Regulation No. 27 (Advanced warning triangles)

Proposal for Supplement 3 to the 03 series of amendments to Regulation No. 27 (Advanced warning triangles)

Submitted by the expert from Germany*

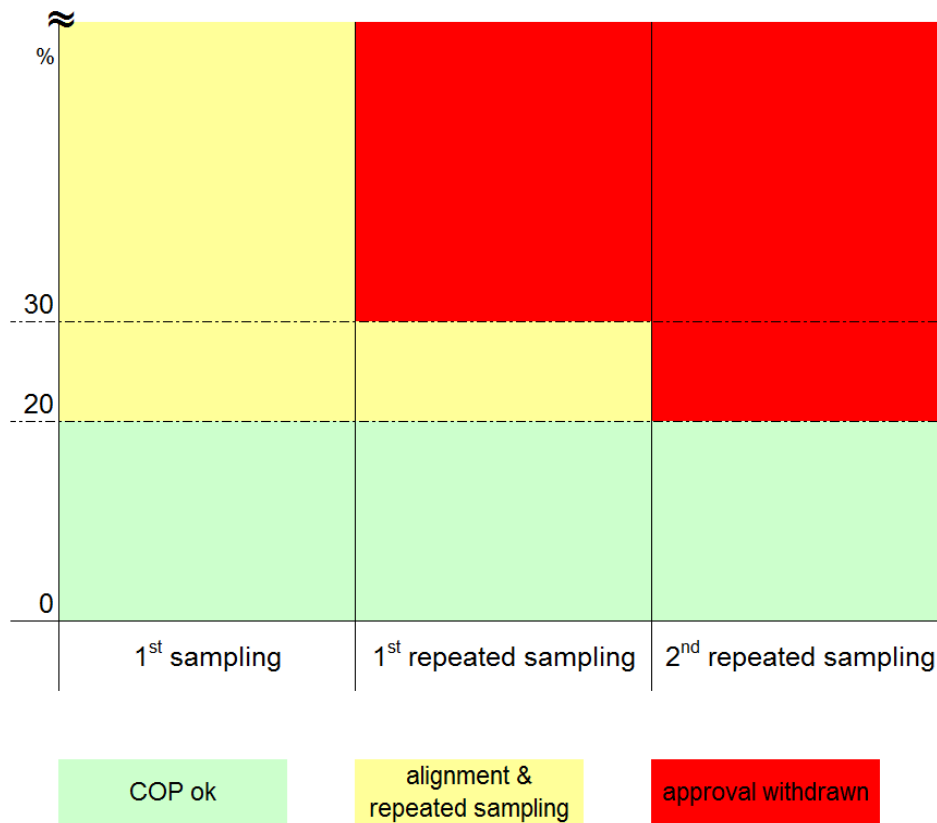
6. Additional Tests

With respect to the verification of the normal use the following procedures shall be applied:

8. The attached drawing shows this stepwise process.

One additional advance-warning triangle shall be tested according to the procedures described in paragraph 1.5.3. to 1.8.3. of Annex 5.

The advance-warning triangles shall be considered as acceptable if the tests have been passed.

However, if the test on this sample is not complied with, the two other additional advance-warning triangles shall be subjected to the same procedure and both shall pass the test."
